2AM-WTP1826

Technical Comment Responses

Whale Tail Pit – Expansion Project

Submitted to:
Nunavut Water Board

Figure ECCC-TC4-1. Annual Precipitation for Period of Record (Baker Lake A)

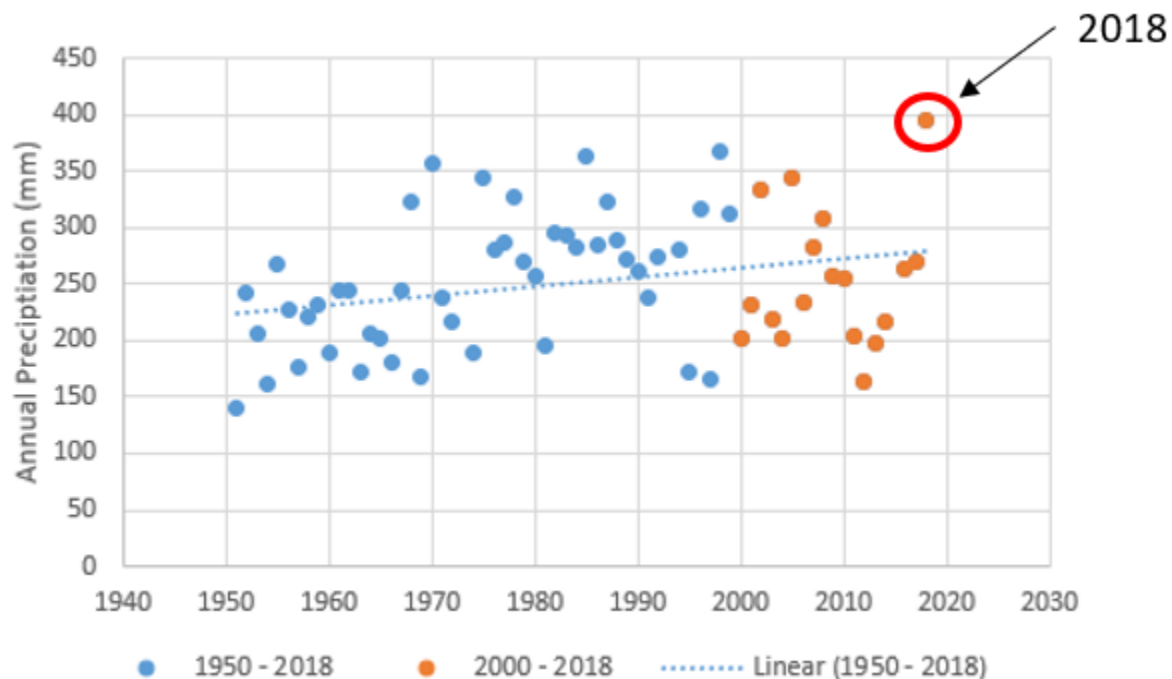
- *Identify the type, extent, timing and duration of water management issues associated with wet climate years that could potentially be encountered for the combined Approved Project and the proposed Expansion Projects.*
- *Clarify how the proposed mitigation measures would address the type, extent, timing and duration of potential water management issues associated with wet climate years for the combined Approved Project and proposed Expansion Projects.*
- *Update the Water Management Plan to incorporate the information requested above.*

Wet precipitation years corresponding to the 10-year and 100-year return periods were derived based on the daily precipitation record from the Baker Lake A Environment and Climate Change Canada (ECCC) Station (ID2300500) precipitation data (1950 – 2018). A frequency analysis was performed on the annual precipitation values derived from the dataset. The resulting annual precipitation is shown in Table ECCC-TC4-1 for the 10-year and 100-year return periods. Average precipitation statistics, available from previous studies (Agnico Eagle 2016), are also presented for comparison.

The precipitation was further corrected for undercatch, using a factor of 1.15 for rainfall and 1.55 for snow-water-equivalent, following previous studies (Agnico Eagle 2016). These factors were developed by ECCC to correct for underestimations of precipitation inherent to measurement limitations, particularly substantial in northern climates, as discussed by Mekis and Hogg (1999). The annual precipitation corrected for undercatch is also shown in Table ECCC-TC4-1.

Total arsenic concentrations in Whale Tail Lake (South Basin)

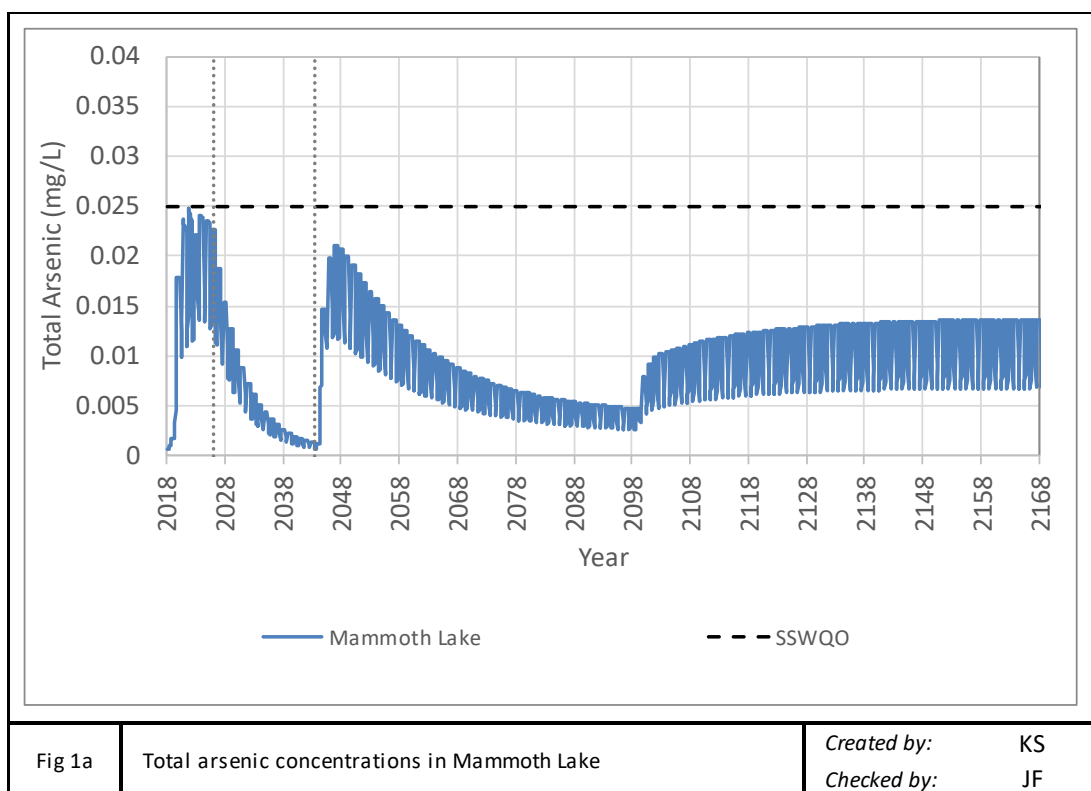
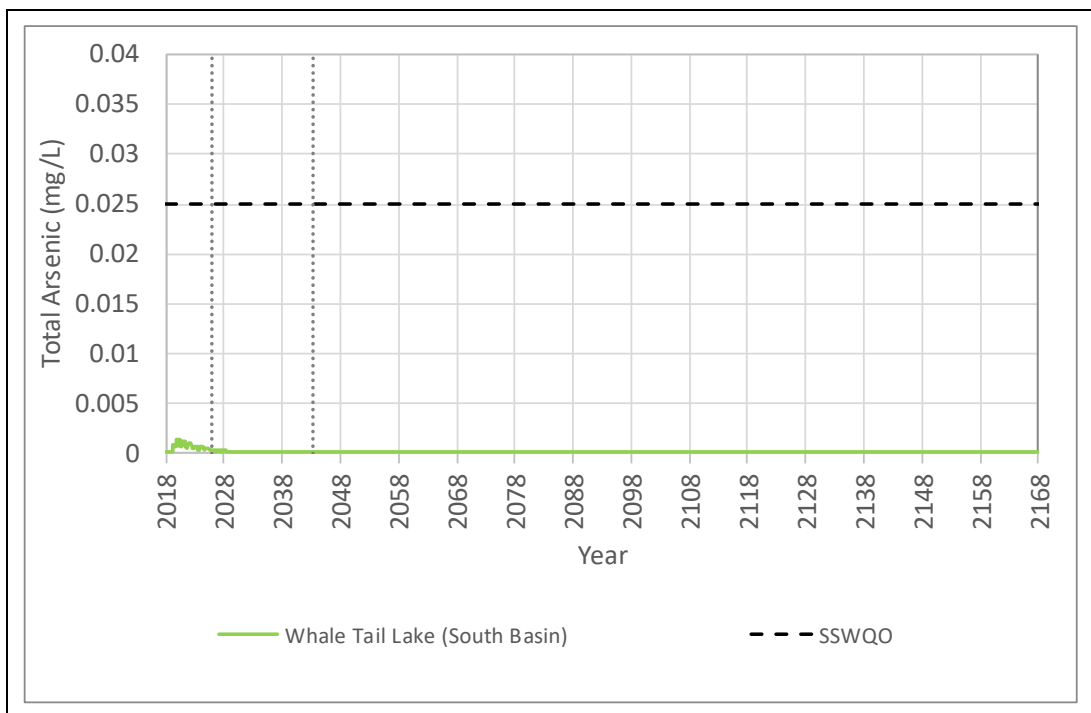
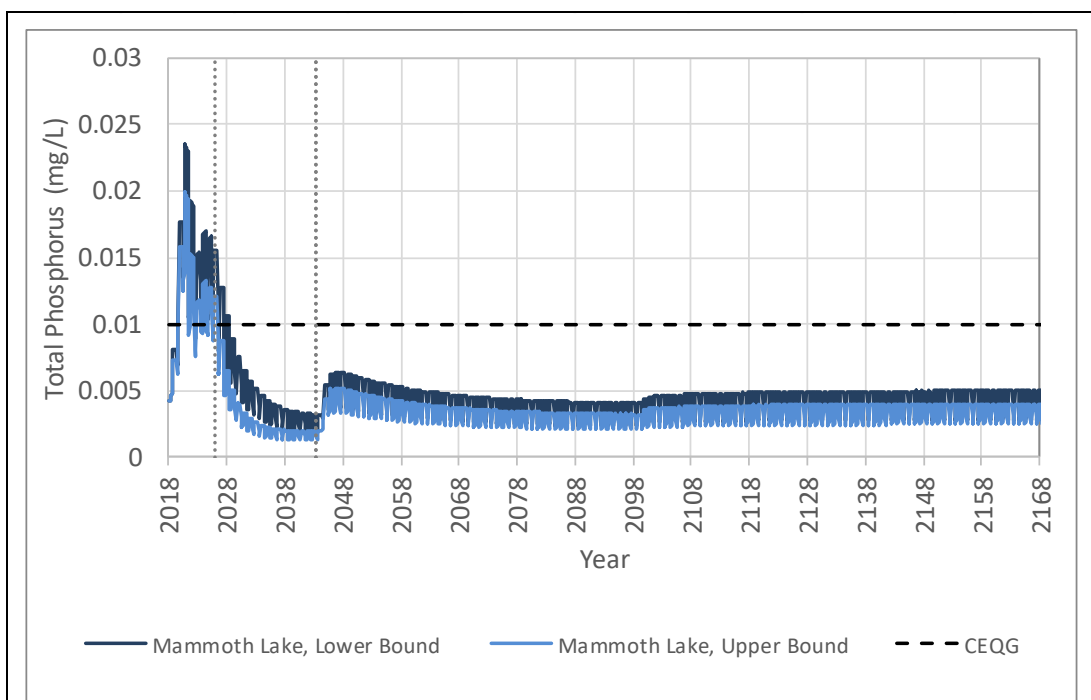
Please update the water quality model to include cryo-concentration. This update should be provided as soon as possible but no later than 30 days prior to the public hearings to provide sufficient time for technical review

The water quality model has been updated to include cryo-concentration; the model has also been updated to include biological phosphorus uptake rates and to include an updated effluent discharge plan. A description of the key assumptions for each of these updates are provided in the table below:

Predicted concentrations for total arsenic and total phosphorus in Mammoth Lake and Whale Tail Lake (South Basin) for the updated water quality modelling are shown below in Figures 1 and 2.
